JEFFERSON STREET BUILDING TECHNOLOGY SUITE TENANT IMPROVEMENT CONSTRUCTION SERVICES

PROJECT NUMBER: 2482-24

ADDENDUM NO. THREE (3)

ISSUE DATE: March 11, 2024

LEVEL 02 RCP FINISHES

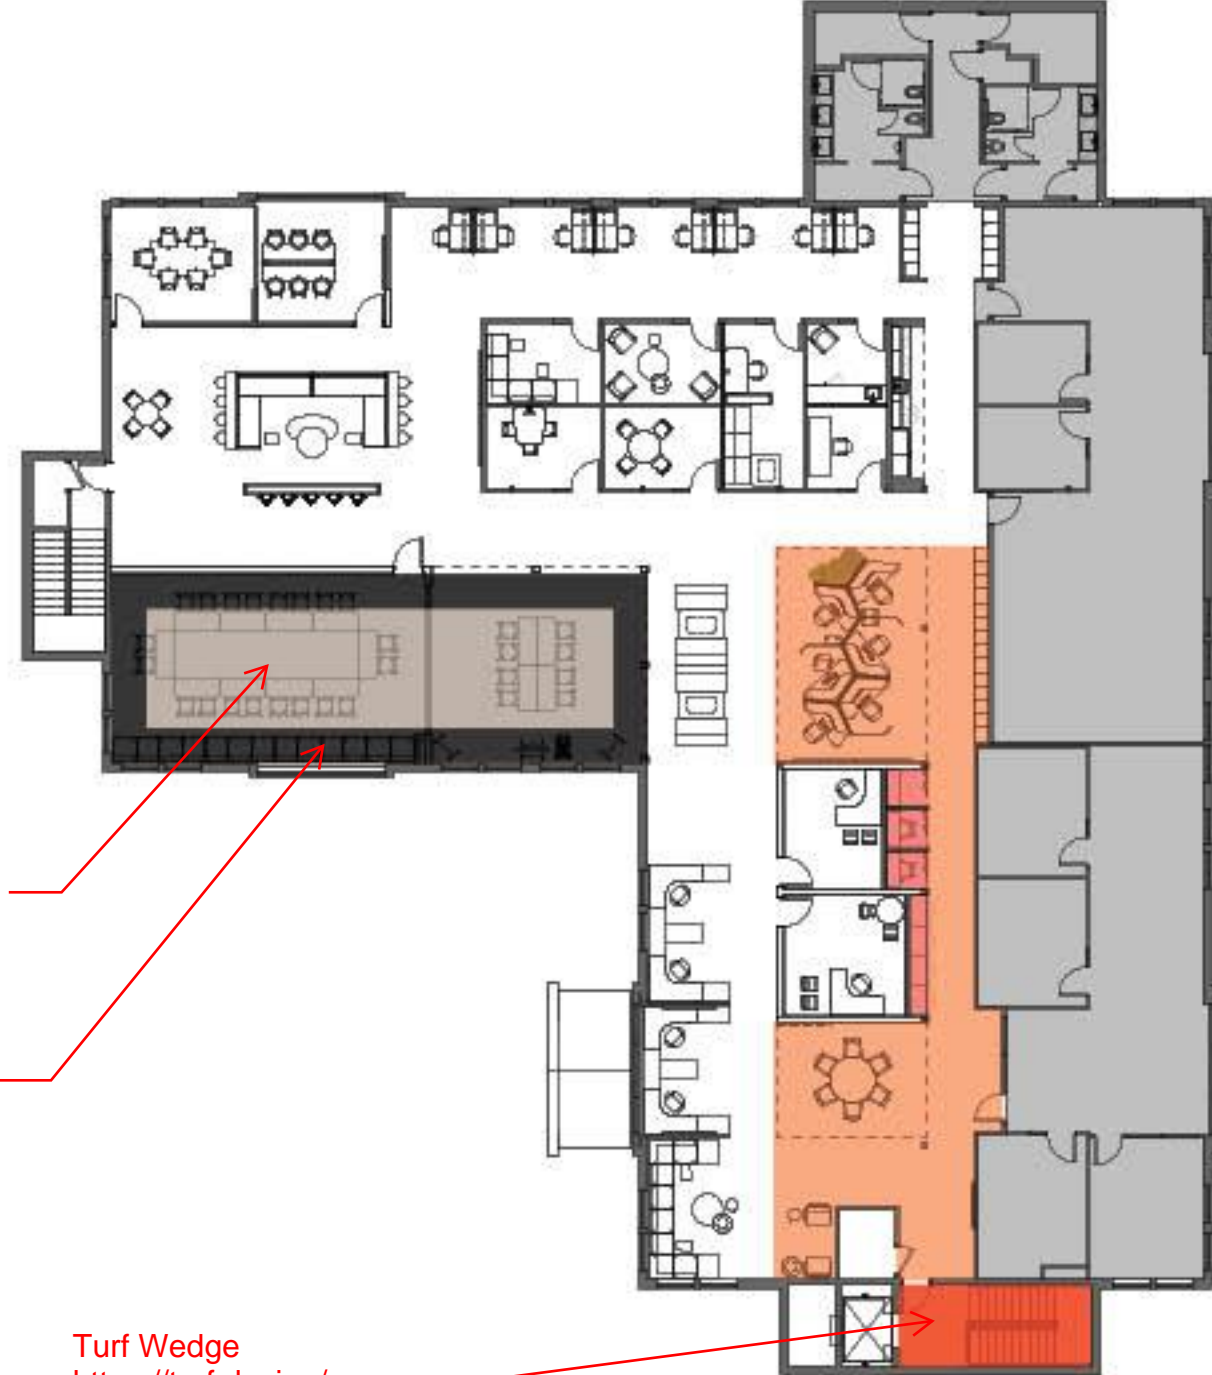
JSB TECH STE TI	
QUESTION	OSU RESPONSE
The finish schedule on sheet G06.01 does not include manufacturer/model or specific material type information for any of the interior finishes (with the exception of glazing and ceiling tiles), and no specifications are provided. Please provide the specified manufacturer/model, or a basis-of-design, for all listed finishes.	See marked up Finish Plan Concepts included with this addendum

New Baffle System

Turf ACT
<https://turf.design/products/port-ceiling-tile>

new painted
Sheetrock lid painted
or equivalent in act.

Turf Wedge
<https://turf.design/products/wedge>

LEVEL 02 CASEWORK FINISHES

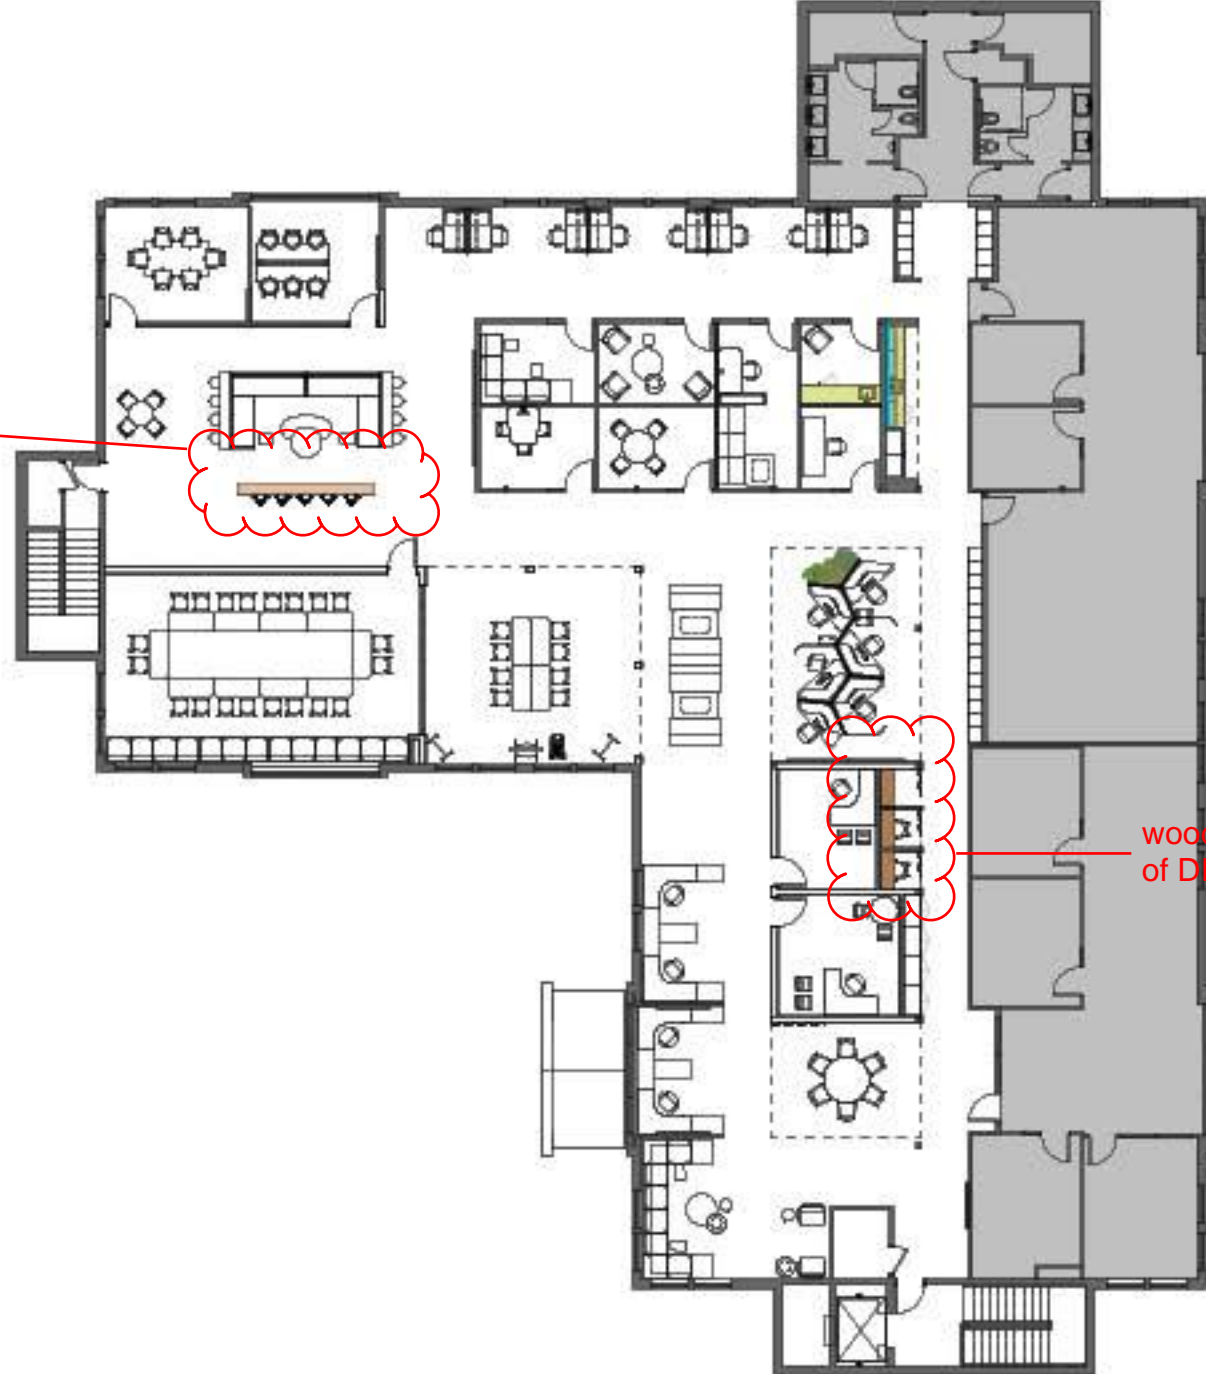
Sheet A11.00 shows the elevated view of the 'Casual Collab Countertop' and notes it to be a plastic laminate finish. However, detail 9 on sheet A12.30 indicates it to be quartz. Please clarify the finish of this countertop surface.	Quartz
The reflected ceiling demolition plan shown on sheet A01.12 indicates removal of the ceiling grid to allow for the new ceiling plan shown on sheet A04.02, but does not show the existing drywall soffits that serve as the header of the cased opening into the existing meeting areas. The soffits are also not shown or addressed in the demo/new floor plans. Please confirm if the headers are to be demolished.	There is no existing header at the current Living Room 154B. Headers needed for Large Conference 260 and Medium Conference 250 enclosure will be provided as part of the DIRT system or approved equal. Existing ACT grid will remain in these locations as well.

quartz same as
pantry

wood countertop part
of DIRT or similar
